STATE OF HAWAII  
DEPARTMENT OF HEALTH  
SAFE DRINKING WATER BRANCH  
ULUAKUPU BLDG. 4  
2385 WAIMANO HOME ROAD, SUITE 110  
PEARL CITY, HI 96782-1400

# HAWAII DEPARTMENT OF HEALTH EVALUATION OF GROUNDWATER FLOW PATHS IN THE MOANALUA, RED HILL, AND HALAWA REGIONS; REVISION 2

July 2019

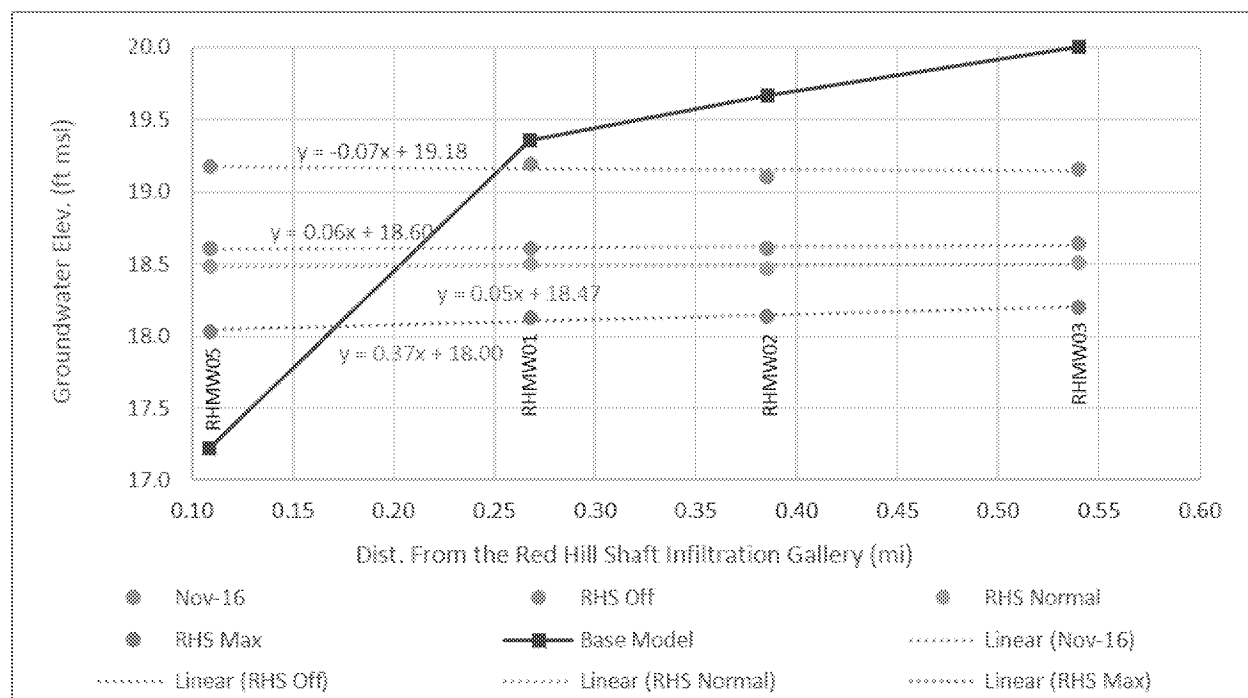
A best fit trend line and equation is included for each pumping condition, where the x scalar value is the groundwater gradient in ft/mi going down the axis of the Red Hill Ridge. A positive x-scalar indicates a gradient in the mauka to makai direction, while a negative x-scalar indicates a gradient in makai to mauka direction or going inland. The x-scalar for the “Nov-16” data set indicates a makai to mauka or inland gradient. The differences in groundwater elevations are so small that the inferred inland gradient must be viewed with caution. Nonetheless, a very small to negative gradient is a strong indicator that

there is little to no natural groundwater flow going down the axis of the Red Hill Ridge when the Red Hill Shaft pumps are not operating. The “RHS OFF” and “RHS Normal” pumping condition data sets both show a very weak mauka to makai gradient with very little difference between the relative water level elevations for two very different pumping conditions. Only when the Red Hill Shaft is pumped at the maximum sustainable capacity is there a definitive mauka to makai gradient. The southwest gradient is still much less than expected suggesting that the majority of groundwater flow is not in that direction. Even then, that gradient is very small at 0.4 ft/mi. These evaluations show that the currently modeled conditions are strongly divergent from those observed.

The typical groundwater gradient toward a pumping center on the Hawaiian Islands is about a foot per mile for the basal aquifers (Oki, 2005; Lau and Mink, 2006). Measured gradients down the axis of the Red Hill Ridge are much smaller than that value (maximum of 0.4 ft/mi when the Red Hill Shaft is pumping at its maximum sustainable capacity). For comparison, Figure 2 shows the water level elevations simulated by the Navy’s Red Hill base groundwater flow model reflecting average 2017 groundwater flow conditions (DON, 2018b) and those measured when the Red Hill Shaft and the Halawa Shaft are pumping at their normal rates. The base groundwater model shows a difference of nearly three feet between the groundwater elevation in RHMW03 and RHMW05, which is a 2-well gradient of more than six ft/mi compared to the measured gradient in this direction of 0.05 ft/mi. The variance between modeled and measured is not within a reasonable range of error. What the model accurately portrays is the groundwater gradient that would be measured if the Navy’s conceptual model of groundwater flow is reasonably correct, and if other parameters such as recharge and the selected hydraulic conductivity are also reasonably correct. Recharge is based on that of Engott (2016), representing the best estimate of recharge available. The selected hydraulic conductivity of 2,000 ft/day is a value that produces good agreement between the modeled and measured water level response to changes in pumping rate at the Red Hill Shaft, increasing the confidence in the selected value for this parameter. DOH’s conclusion is that the Base Model results show that the Navy’s conceptual model of groundwater flow needs significant revision.

groundwater flow field. The groundwater flow field is determined by the modeled groundwater gradient. As shown in Figure 2, the model groundwater gradient bears very little resemblance to the measured gradient. Since the model does not accurately replicate the groundwater gradient the capture zones for the Red Hill Shaft, and also the Halawa Shaft remain un-delineated. To revise the groundwater model to produce gradients that result in defensible capture zone delineations may require a re-evaluation of the model boundary conditions or the hydraulic parameter values used for the non-basalt geology in the model. The selected values for the basalt hydraulic conductivity and effective porosity do not need significant revision since the simulated aquifer response to Red Hill Shaft pumping and non-pumping cycles was similar to that measured by the synoptic water level monitoring. This leaves changing other model inputs such as the boundary conditions to produce defensible hydraulic gradients upon which to delineate capture zones.

Figure 4. A conductivity-temperature-depth profile of HDMW2253-03, and a conceptualization of the upward and outward flow of brackish water into the formation. The water in the wellbore abruptly shifts from brackish to fresh at -100 ft msl

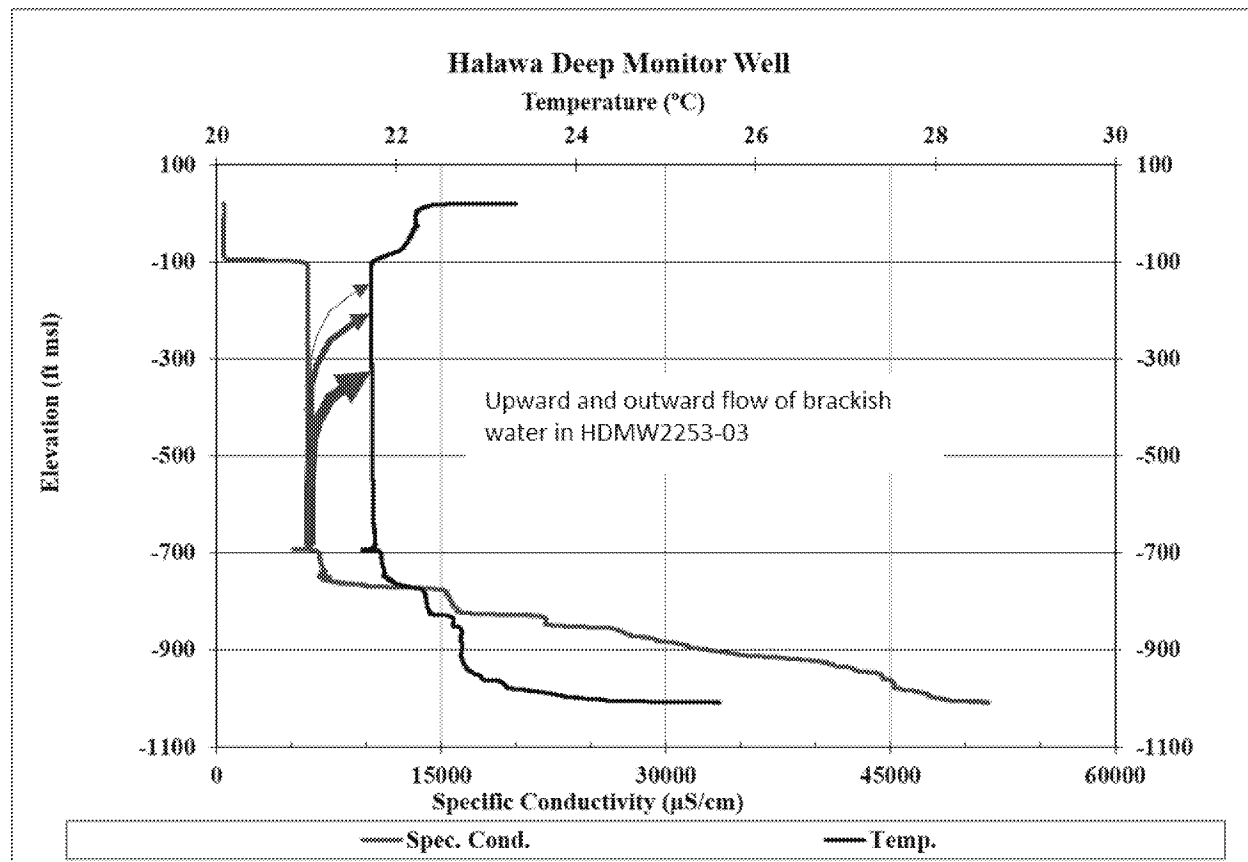
In LOE No. 6, the Navy proposes that a sodium-chloride type water from north of South Halawa Valley is mixing with a sodium-bicarbonate type water from the southeast. The Navy hypothesizes that water from the brackish zone of HDMW2253-03 is influencing the chemistry of RHMW06 and RHMW07 showing that groundwater flows from north of South Halawa Valley to these wells (DON, 2018a, Section 6.7). Figure 4 shows a conductivity-temperature-depth profile for HDMW2253-03 and a conceptualization of flow within the wellbore based on this profile and the borehole video presented to the AOC parties in March 2019. This video is held by the Commission on Water Resources Management and arrangements to view this video can be made with this agency. The groundwater within the wellbore of HDMW2253-03 shifts abruptly from brackish to fresh at -100 ft msl. For the Navy to support their hypothesis that the saltiness of RHMW06 and RHMW07 is due to the up flow of brackish water from HDMW2253-03 they need to explain how cooler denser water can pass beneath the hypothesized saprolite barrier and rise from -100 ft msl to about 15 ft msl and warm significantly in the process. It seems much easier to reconcile the saltiness of RHMW06 and RHMW07 with the warm brackish water in Oily Waste Disposal Basin (OWDB). As stated in the Navy's hypothesis the sodium-chloride type water from north of South Halawa Valley mixes with sodium-bicarbonate type water from the southeast. This

would infer an inflow of groundwater from the southeast, not from the northeast and is inconsistent with the Navy's conceptual model of groundwater flow from the northeast to the southwest.

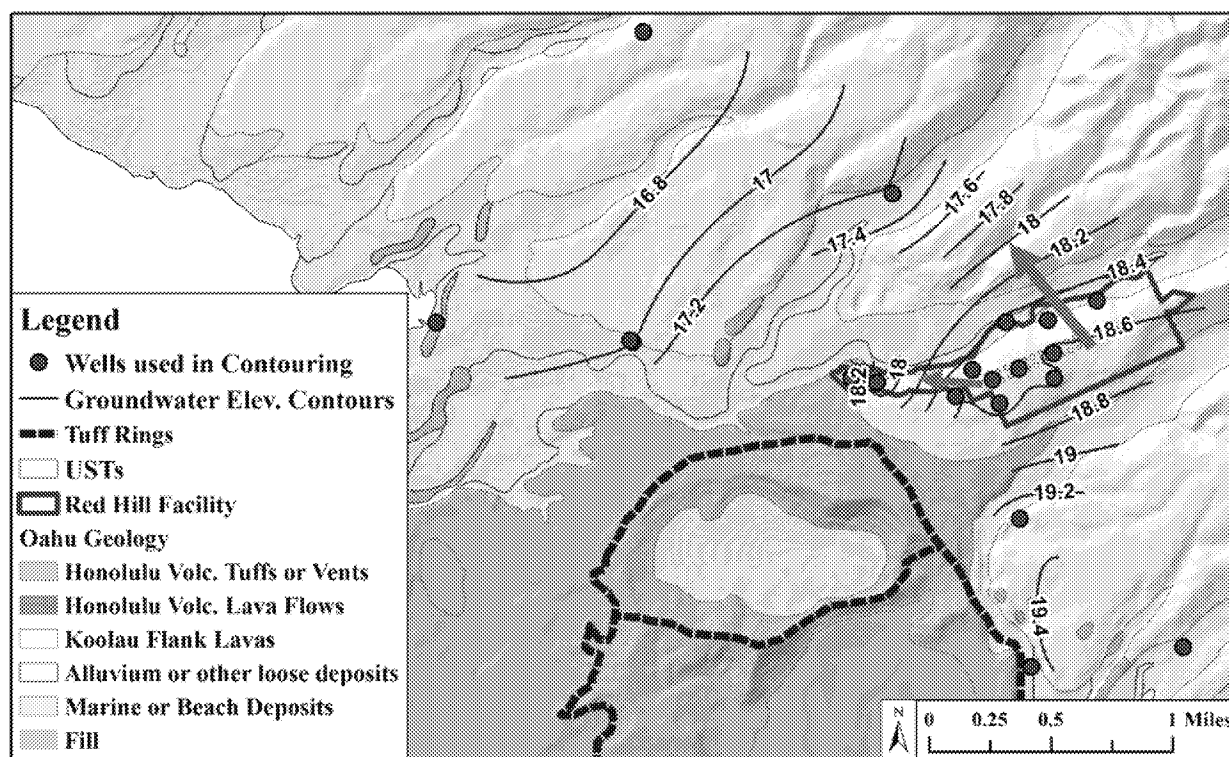
Moanalua Ridge to the Red Hill Ridge, then drops an additional 1.4 ft from the Red Hill Ridge to the North side of North Halawa Valley. There are too few points in the Moanalua area to confidently define a groundwater gradient. However, beneath the Red Hill Ridge the groundwater contours generally run parallel to the axis of the ridge down to about RHMW05, then contours are more oblique to the axis of the ridge producing an inferred gradient in a westerly direction. It is also important to note that the highest water levels are in those wells aligned with the axis of the ridge whereas the wells on the flanks of the ridge have slightly lower groundwater elevations. As a group, the wells that are on the northwest flank of the Red Hill Ridge have the lowest groundwater elevations. On the north side of North Halawa Valley in the Halawa-Aiea area the data are sparse, but the northeast to southwest trending groundwater contour pattern continues suggesting groundwater flow to the northwest (i.e. perpendicular to the groundwater elevation contours). The most northwest well is the Kaamilo Deep Monitoring Well. Like HDMW2253-03, the depth versus specific conductivity profile indicates strong intra-borehole flow that could bias the water levels measured in this well. The groundwater elevation contours beneath the Red Hill Ridge and beneath the Halawa-Aiea area indicate that at least where the penetration of the saprolite into aquifer is either shallow or non-existent, the relative groundwater elevations indicate groundwater flow to the northwest. More specifically, the groundwater contouring strongly suggests that the flow direction beneath the upper part of the facility is to the northwest. This observation is in direct contrast to the Navy's expectation that the water flows along the shortest mauka to makai path from the high elevation recharge areas to the coast.

Figure 6. Groundwater elevation contours for the Red Hill Groundwater Monitoring Network when the Red Hill Shaft is pumping at a normal rate. Data based on Figure 6-12 in the Red Hill CSM (DON, 2018a)

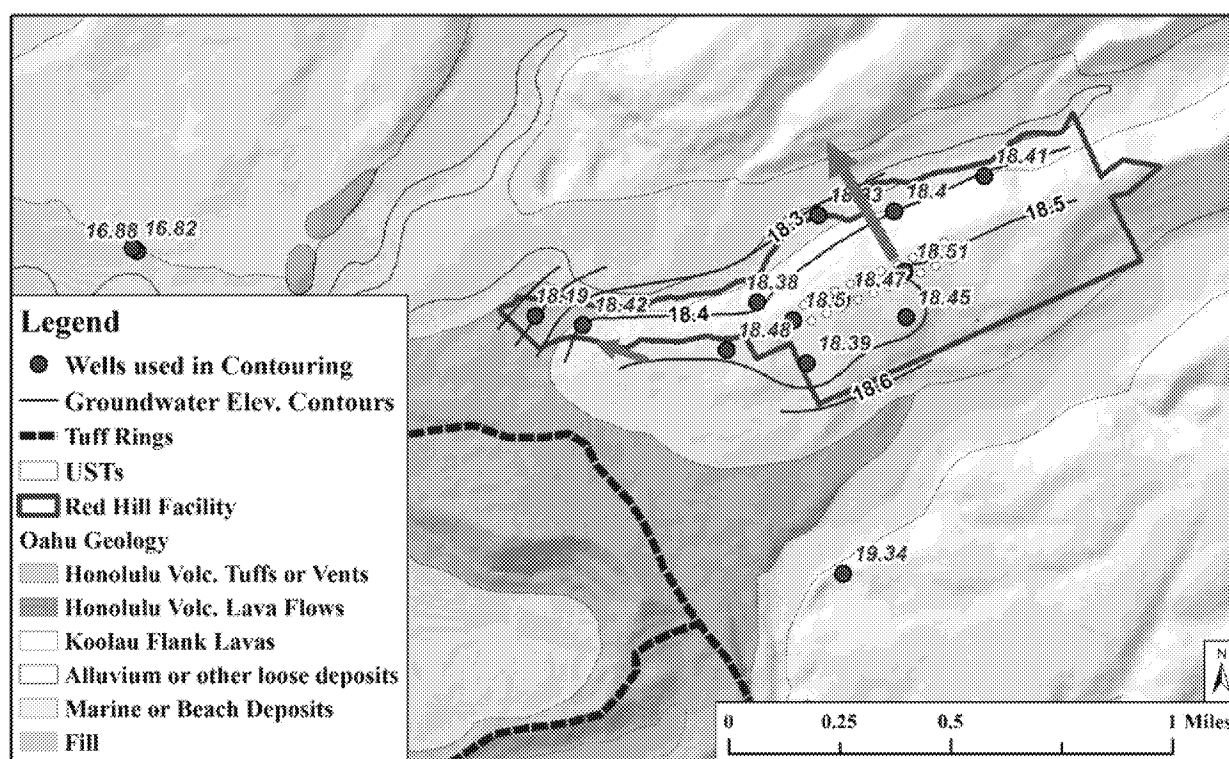
Figure 6 shows groundwater contours drawn for the RHGWMNW only and using a 0.1 ft contour interval. The water levels measured at the wells are shown as the red numbers while contour labels are shown as black numbers. This figure represents a condition where the Red Hill and Halawa Shafts are pumping at their normal rates with the data taken from Figure 6-12 of DON 2018a. As with the previous set of contours these trend from northeast to southwest indicating a northwest gradient for groundwater in the upper part of the Facility, beneath the USTs. The northwest gradient indicates the likely direction of groundwater flow in absence of any barrier that resists groundwater flow in that direction.

Figure 7. Estimated depth to which the saprolite extends into the freshwater aquifer expressed as the percent of total aquifer thickness penetrated by the saprolite.

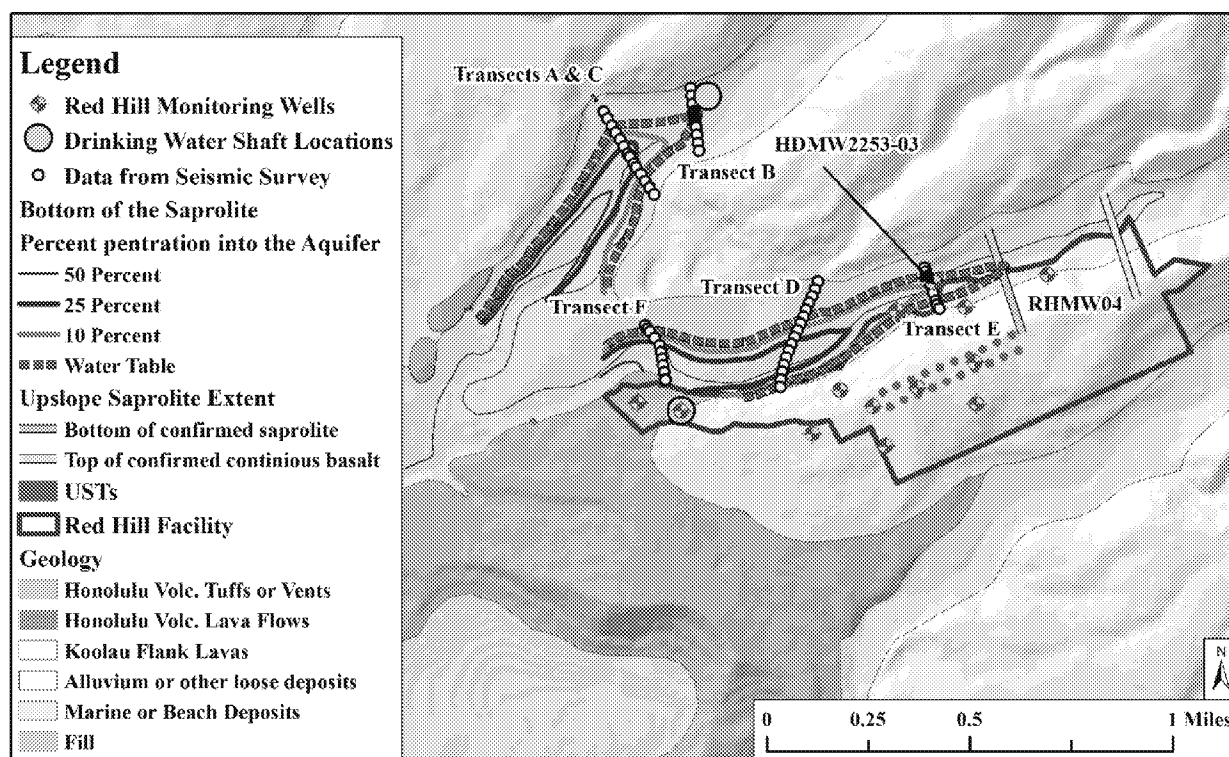
The purpose of these geometric projections was to develop a three-dimensional surface of the saprolite/basalt interface. Contour lines were then generated representing the trace of the saprolite/basalt interface at: 1) the water table; and 2) at depths of 10, 25, and 50 percent of the aquifer thickness. The results of these evaluations are shown in Figure 7. The saprolite/basalt interface of this evaluation is consistent with the most down valley point estimated by the Navy and roughly adjacent to the Tank 19. The point at which the saprolite/basalt interface reaches a 25 percent of the aquifer thickness does not occur until a point roughly adjacent to Tank 1. It is important to note that this evaluation used the deepest estimated depth of the saprolite/basalt interface at HDMW2253-03, yet using the saprolite/basalt interface slope calculated from the seismic data rather than using a literature value, the point at which this interface rises above the water table was very close to what the Navy estimated using the shallowest saprolite/basalt interface depth at this well. In North Halawa Valley, the deepest saprolite/Basalt interface depth estimated by seismic survey at Transect B was -20 ft msl. Projecting up North Halawa Valley the saprolite/basalt interface is estimated to rise above the water table slightly before the Halawa Shaft.

The important conclusion of this saprolite/basalt interface depth evaluation is that the resistance to northwest groundwater flow posed by the valley fill/saprolite sequence is likely over-estimated by the Navy's current conceptual model. Extrapolations based on the seismic study indicates that the valley fill/saprolite sequence likely poses little resistance to groundwater flow in the South Halawa Valley adjacent to the USTs and in North Halawa valley adjacent to the Halawa Shaft. As Figure 7 shows, the aquifer penetration of the valley fill/saprolite sequence in South Halawa Valley is less than 50 percent for nearly the entire length of this valley that is adjacent to the Facility. This is concerning since the 2015 and the 2017-2018 Synoptic Water Level Studies show that groundwater elevation at RHMW04 is about a foot higher than at the Halawa Shaft; and the groundwater elevation at OWDF-MW1 is 1.5 ft higher than at HBWS observation well T-45. With this difference in head across Halawa Valley and the limited saprolite penetration, groundwater almost certainly flows from Red Hill beneath and around the valley fill/saprolite sequence to the Halawa side of North Halawa Valley.
